This is a recreated compact version of the 2023 State Electrical Code Amendment Package. The official version is located in the archives of the Building Code Council agendas. Report errors to the State Electrical Division of the North Carolina Office of State Fire Marshal. JDS 3/4/2024

Article 10 - ADMINISTRATIVE SECTION

Figure 410.16(A) Exception : Clothes Closet Storage Space Exception

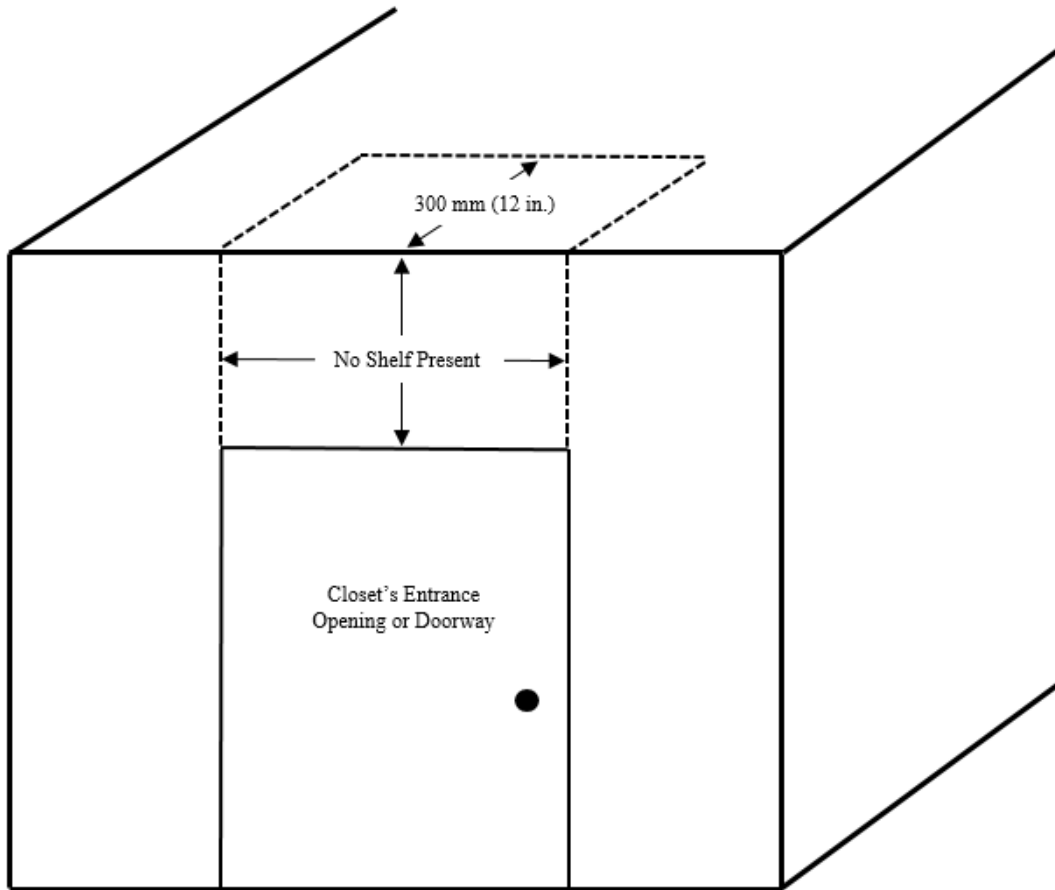
Item 25: Adding Exception to definition of Closet Storage Space in section 410.16(A) for clarification with NC Building Designs

Exception: Where a shelf is not present in the area of wall above the closet's entrance opening or doorway extending from the top of such opening or doorway vertically to the ceiling, including the area of ceiling extending perpendicular from the area of wall directly above the closet's entrance opening or doorway to a horizontal distance of 300 mm (12 in.), shall not be defined as closet storage space. See Figure 410.16(A) Exception.
